Well Name: ROARING SPRINGS 14 FED	Well Location: T21S / R23E / SEC 14 / NWSW /	County or Parish/State: EDDY / NM
Well Number: 6	Type of Well: CONVENTIONAL GAS WELL	Allottee or Tribe Name:
Lease Number: NMNM76919	Unit or CA Name:	Unit or CA Number:
US Well Number: 300153034700S1	Well Status: Producing Oil Well	Operator: OXY USA WTP LP

Notice of Intent

Type of Submission: Notice of Intent	Type of Action Plug and Abandonment
Date Sundry Submitted: 05/10/2021	Time Sundry Submitted: 11:51
Date proposed operation will begin: 08/01/2021

OPERATOR'S NAME:	OXY USA WTP LP
LEASE NO.:	NMNM76919
WELL NAME & NO.:	Roaring Springs 14 Fed 6
US Well Number:	3001530347
LOCATION:	Section 14, T.21 S., R.23 E., NMPM
COUNTY:	Eddy County, New Mexico

Roaring Springs 14 Federal #006 - Proposed

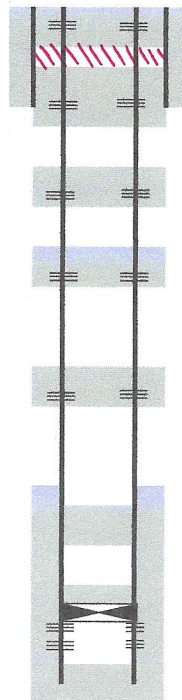
1. POOH with tubing and equipment.
2. RIH & set CIBP @ 7377'. Tag & leak test. Dump bail 35' class c cmt to 7342'. WOC – Tag.
3. M&P ^{30 SX} 25sx class c cmt from 6620' to ^{6454'} 6504'. WOC-Tag
4. Perf @ 5646', sqz 50sx class c cmt f/ 5696' to 5571'. WOC – Tag.
5. Perf @ ^{3754'} 3704', sqz 50sx class c cmt f/ 3754' to ^{3616'} 3629'. WOC – Tag. (In/Out)
6. Perf @ ^{2150'} 2100', sqz 50sx class c cmt f/ 2150' to 2025'. WOC – Tag. (In/Out)
7. Perf @ ^{1257'} 1207', sqz ^{365'} 150sx class c cmt f/ 1257' to ^{surface} 868'. WOC – Tag. (In/Out) Verify @ surface.
8. ~~Perf @ 400', sqz 150sx class c cmt from 400' to surface. WOC. Verify cement to surface.~~

~~Perf @ 400', sqz 450sx class c cmt from 400' to Surface. WOC. Verify cmt to Surface.~~

1257' 365' surface
 Perf @ 1207', sqz 150sx class c cmt from 1257' to 868' WOC -Tag (Sn/Out)
 Verify @ surface

2150'
 Perf @ 2100', sqz 50sx class c cmt from 2150' to 2025' WOC -Tag (Sn/Out)

3754' 3616'
 Perf @ 3704', sqz 50sx class c cmt from 3754' to 3629' WOC -Tag (Sn/Out)

305x 6454'
 M&P 25sx class c cmt from 6620' to 6504' WOC-Tag
